Access Compliance Report

Public Rights-of-Way

(Pedestrian Signals)

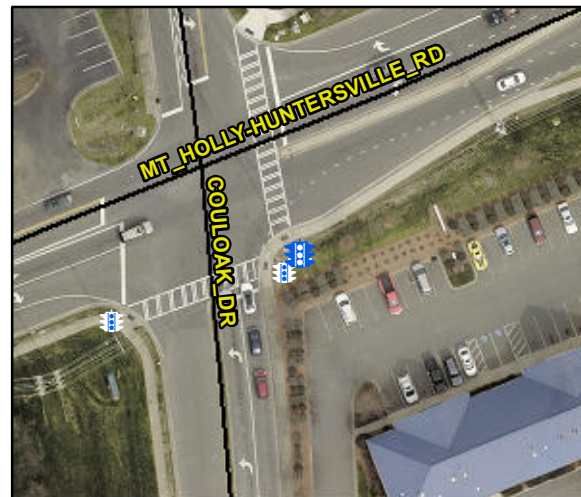
PROW/ADA: , R404.2, R404.3, R404.7.2

Compliance	Description	Data	Compliance	Description	Data
	Button Count	Button1	No	Distant to Additional Button (in)	94.0
	Additional Button Present?	Yes		Additional Button ID	BFABF6AF608D
N/A	Signal Buttons Required?	N/A	N/A	Additional Ped Posts Required	N/A
	How Many Ped Street Xings?	N/A		Located In An Island/Median?	N/A
N/A	B 1 Sign Present?	Yes	N/A	B 2 Sign Present?	N/A
Yes	B 1 Sign Purpose?	Yes	N/A	B 2 Sign Purpose?	N/A
Yes	B 1 Sign Lettering & Contrast?	Yes	N/A	B 2 Sign Lettering & Contrast?	N/A
Yes	B 1 Parallel To XWalk?	Yes	N/A	B 2 Parallel To XWalk?	N/A
Yes	B 1 PAR to Button?	Yes	N/A	B 2 PAR to Button?	N/A
Yes	B 1 PAR to XWalk?	Yes	N/A	B 2 PAR to XWalk?	N/A
Yes	B 1 Clear Floor Space?	Yes	N/A	B 2 Clear Floor Space?	N/A
N/A	B 1 FWD Approach?	No	N/A	B 2 FWD Approach?	N/A
N/A	B 1 FWD Approach Constrained?	N/A	N/A	B 2 FWD Approach Constrained?	N/A
N/A	B 1 FWD Approach Reach (in)	N/A	N/A	B 2 FWD Approach Reach (in)	N/A

N/A	B 1 FWD Approach Width (in)	N/A	N/A	B 2 FWD Approach Width (in)	N/A
N/A	B 1 FWD Approach Obstruction?	Yes	N/A	B 2 FWD Approach Obstruction?	N/A
N/A	B 1 FWD Approach Obstruction Dist (in)	3.0	N/A	B 2 FWD Approach ObstructionDist (in)	N/A
N/A	B 1 PARA Approach?	Yes	N/A	B 2 PARA Approach?	N/A
N/A	B 1 PARA Approach Constrained?	Yes	N/A	B 2 PARA Approach Constrained?	N/A
Yes	B 1 PARA Approach Reach (in)	8.0	N/A	B 2 PARA Approach Reach (in)	N/A
No	B 1 PARA Approach Width (in)	48.0	N/A	B 2 PARA Approach Width (in)	N/A
N/A	B 1 PARA Approach Obstruction?	Yes	N/A	B 2 PARA Approach Obstruction?	N/A
N/A	B 1 PARA Approach Obstruction Dist (in)	3.0	N/A	B 2 PARA Approach ObstructionDist (in)	N/A
No	B 1 Clear Floor Space Slope (%)	2.3	N/A	B 2 Clear Floor Space Slope (%)	N/A
Yes	B 1 Clear Floor Space XSlope (%)	1.0	N/A	B 2 Clear Floor Space XSlope (%)	N/A
N/A	B 1 PAR Slope (%)	N/A	N/A	B 2 PAR Slope (%)	N/A
Yes	B 1 Height (in)	40.0	N/A	B 2 Height (in)	N/A

Possible Solutions: Replace Signal Push Button With APS Button on New Post. Remove & Relocate Sign.
